NUCLEAR REGULATORY COMMISSION

Title: Advisory Committee on Reactor Safeguards
Nu-Scale Design Centered Subcommittee

Date: Tuesday, February 18, 2025

FSAR Figure 6.2-1: Containment System

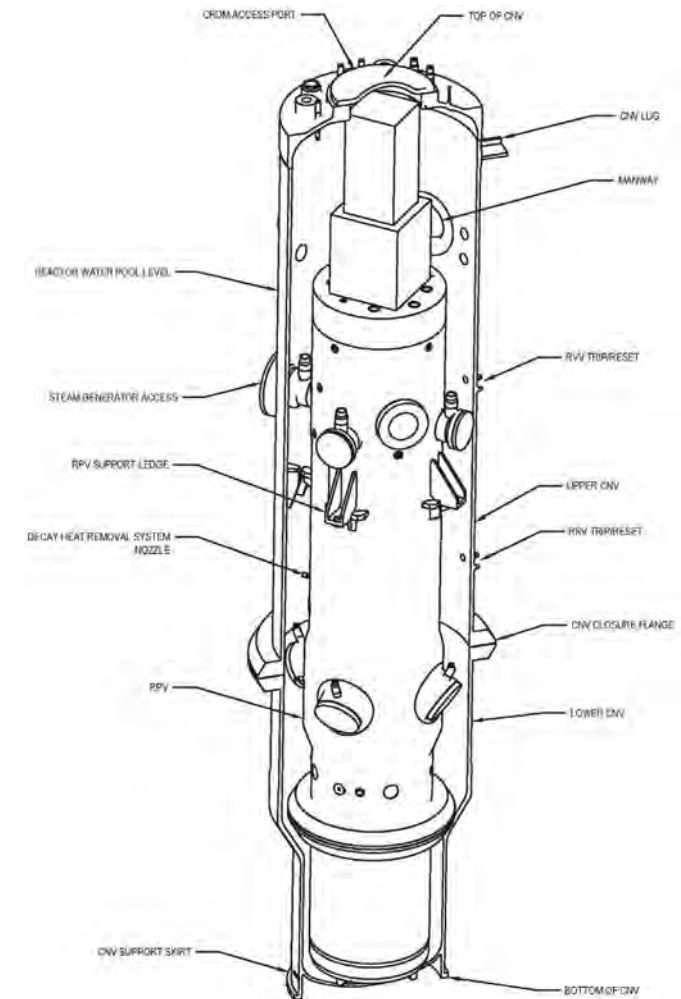
4 So in this design, we include a safety-
5 related passive autocatalytic recombiner or PAR. And
6 that maintains an inert containment atmosphere. With
7 that change, it removes potential combustion loads
8 because flammability precluded in an inert environment
9 is maintained. And it also coincides with the
10 exemption we have for combustible gas monitoring
11 requirements. And so there are no combustible gas
12 monitoring provisions strictly in the containment
13 vessel.

14 MEMBER ROBERTS: Tyler, this Tom Roberts.
15 The removal of combustion loads will maintain an inert
16 environment, reading through the staff's SE, they seem
17 to indicate that you have maintained the combustion
18 load. And there's an RAI where you discuss that you
19 did the analysis to show that you could still
20 withstand a combustion load if it were to occur. So
21 I'm a little confused as to what's the intent of that.
22 Is the intent to -- or I would say, what is the
23 intent?

2 MEMBER ROBERTS: It's the Chapter 19 RAI
3 that has a change in Chapter 6 in it. And the staff's
4 Chapter 6 safety evaluation basically talked about
5 that. It says part of the basis for accepting the
6 pressure table of the PAR is you still have the
7 analysis that you can withstand the combustion load
8 even if the PAR is there to inert the environment.
9 You've still got the analysis and if you had the
10 detonation, it would still be covered. I was trying
11 to understand what would that bullet mean.

2 MEMBER MARTIN: I wanted to get a
3 clarification on your last bullet regarding exemption
4 from monitoring requirements. You obviously are going
5 to -- I mean, it's an essential vacuum, right? You
6 will be monitoring pressure which would be basically
7 zero all the time, correct?

8 What do you mean specifically by that?
9 Because you have to have some safety-related
10 monitoring because it might -- and if you had air in
11 there, again, that's a source term of the combustion
12 event. That would factor back into, say, a design
13 basis analysis because air would affect, say,
14 condensation rates and such like that. I want to give
15 you an opportunity to clarify what you mean by
16 monitoring requirements.

FSAR Figure 6.2-4: Primary System
Containment Isolation Valves Dual
Vale, Single Body Design

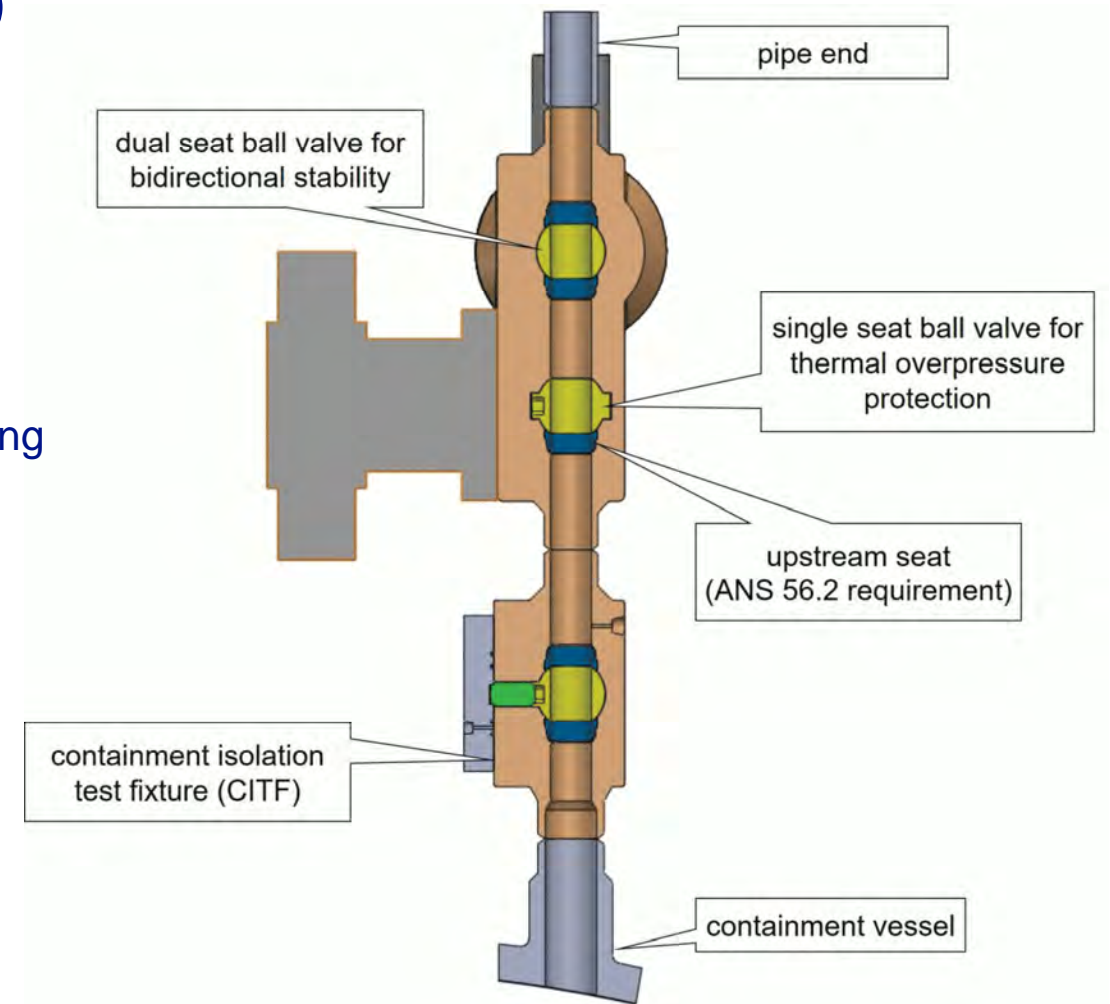
23 MR. BECK: Next slide. Continuing on
24 containment changes for containment isolation. A
25 significant change from the DCA is the addition of a

11 And you can see that depicted on a picture
12 in the right side where CITF is. There also was a
13 change in the closure time of CIVs which was changed
14 from 7 seconds to 10 seconds now in the SDA.

FSAR Figure 6.3-2: Emergency Core Cooling System Operation

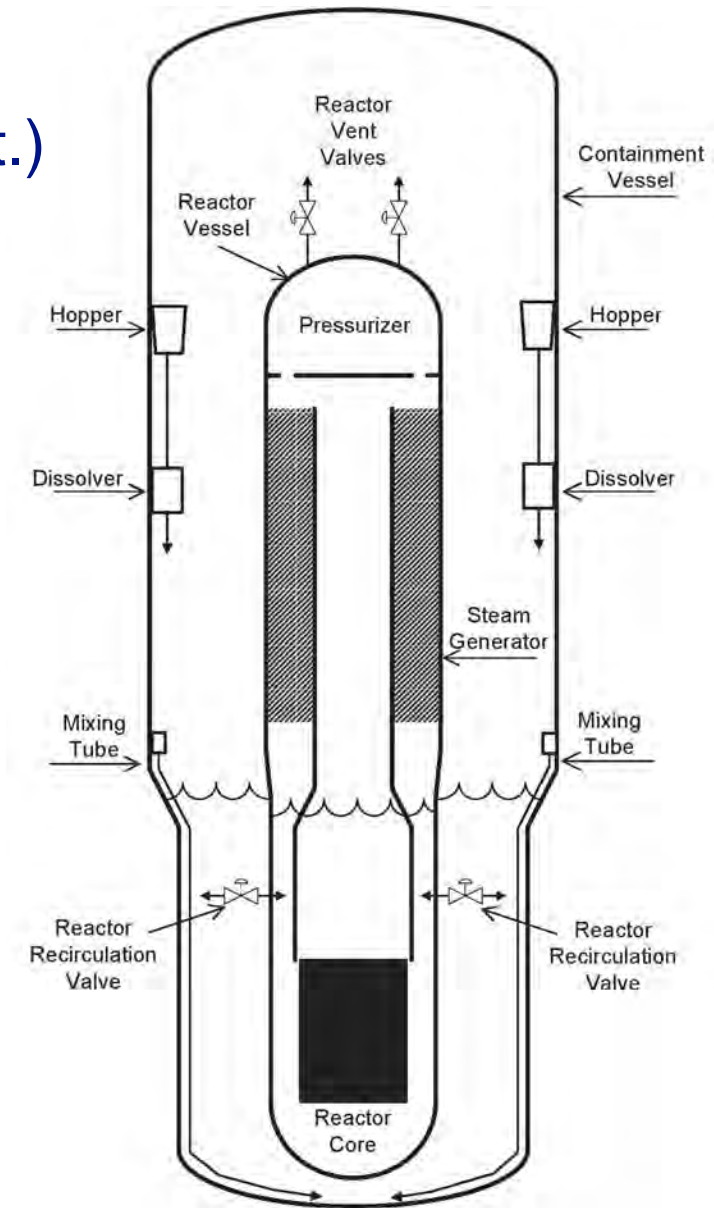
5 MEMBER HARRINGTON: One other question on
6 the IAB. Clear the block at 450 psid differential
7 pressure. And at that point, I don't remember there
8 being a discussion on this. But it seems like
9 obviously you would then be flowing water out the RRV
10 instead of flowing back in. Is that a problem or why
11 pick 450 and not some lower differential?

Detail from FSAR Figure 6.3-5: ECCS
Emergency Supplemental Boron Feature Details

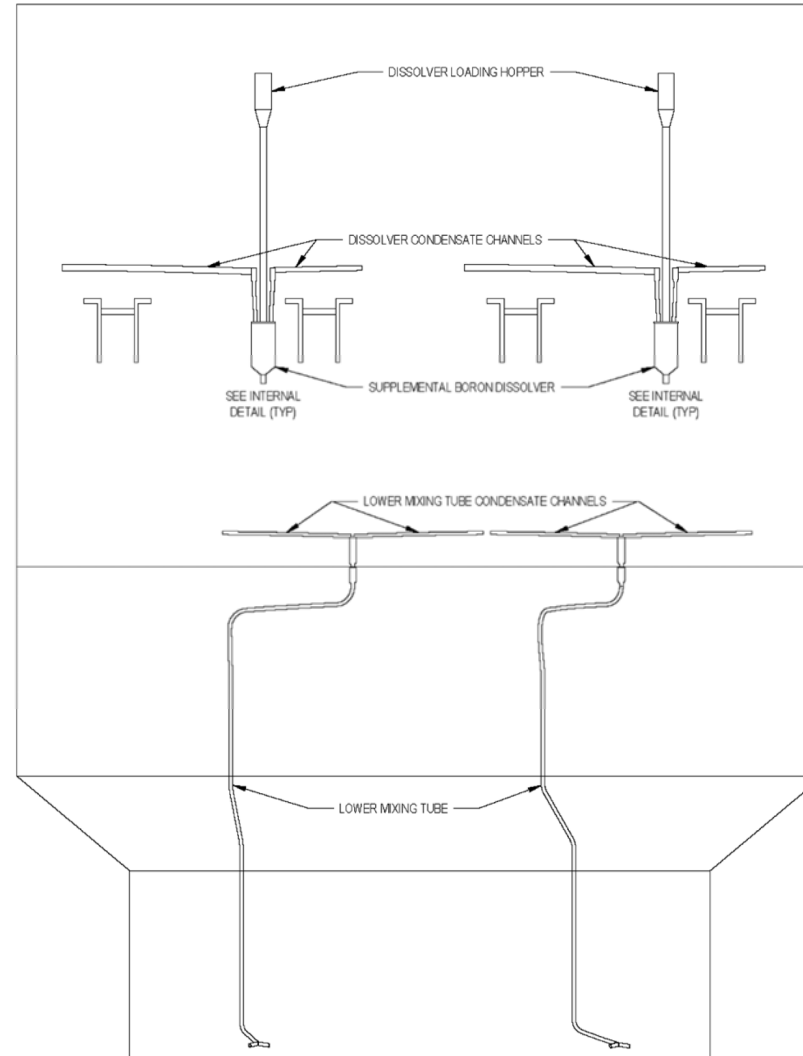
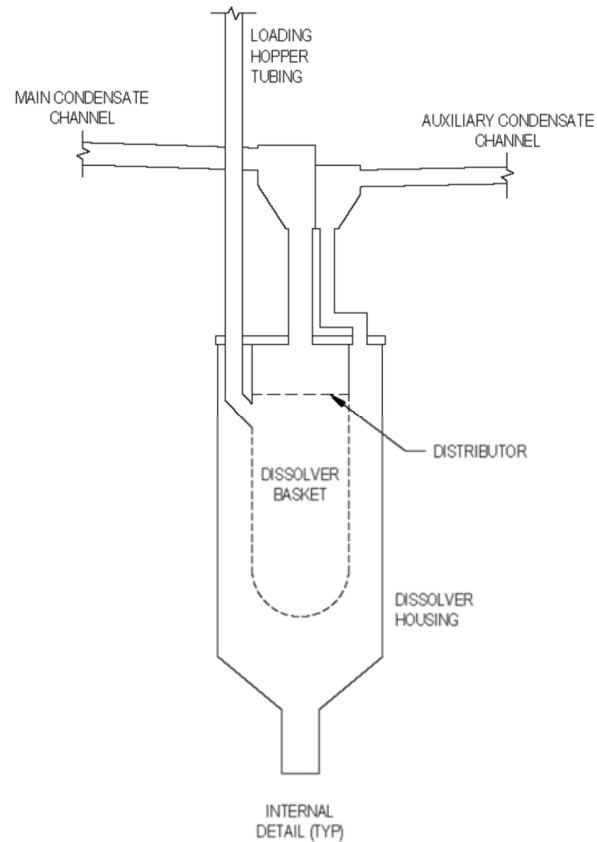
3 You can see the hoppers, dissolvers, and
4 mixing tubes. And on the next slide, there's another
5 picture that's a little bit more detailed of the FSAR.
6 It shows more detail to the ESB system. I'll show
7 that in a second.

6 CHAIR KIRCHNER: Yeah. But they would be
7 in a moisture environment. So the water level
8 basically in the revised design for the SDAA, where
9 would the water level be under normal operations in
10 the reactor building, about the hopper level, below
11 it? I think it would be below, right?

18 MR. BECK: -- the question on temperature
19 and the conditions, yes, the pellets and ESB are
20 included in the environmental qualification program.
21 They are qualified for that environment.

Staff Confirmatory Analysis Results for the SDAA NPM-20 CNV

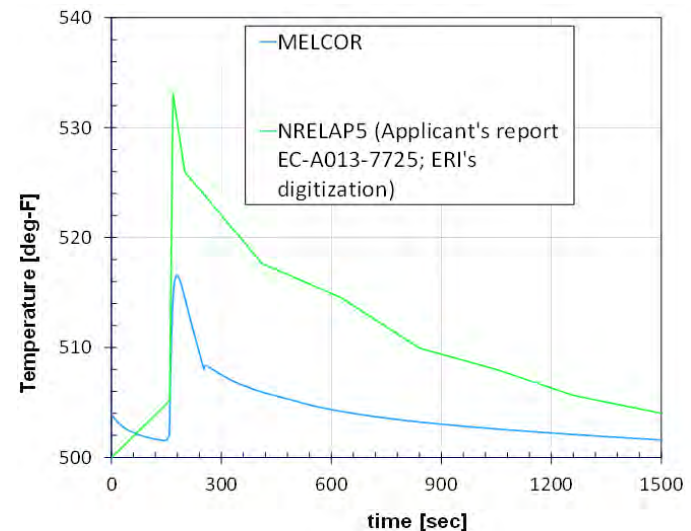
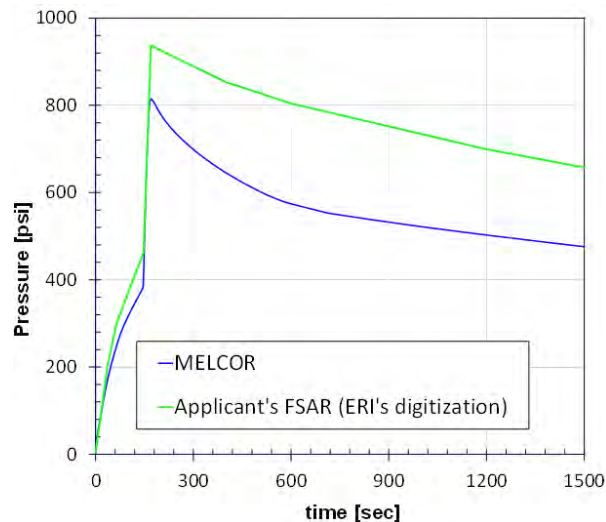
18 Next slide, please. So I have entered
19 this slide to show the comparison between the staff
20 confirmatory analysis and also the Applicant's
21 analysis. So basically this slide is showing that the
22 staff's -- that the Applicant's analysis is
23 conservative.

12 But what I think that this doesn't say is
13 that, more than likely, I think I would have more
14 confidence in the MELCOR prediction of containment
15 response, given its history and validation. And then
16 you're certainly confirming significant margin,
17 whether NuScale has quantified it or not, but it gives
18 us a lot of confidence.

19 MR. HAIDER: But I would like to also add
20 one more piece of information that I believe is
21 relevant in this context. In the DCA, the peak
22 containment pressure was predicted by RELAP at about
23 994. And we literally used a very similar containment
24 volume model using MELCOR in the DCA stage. And it
25 predicted around 986.

3 MR. HAIDER: So we were very close. And
4 the same model was modified in RELAP5 for SDAA, using
5 the modified initial conditions, and literally, they
6 are using the same condensation model, the same models
7 for critical flow and the same model for decay heat.
8 But, yes, the pressure came out far below. But TRACE
9 is also --
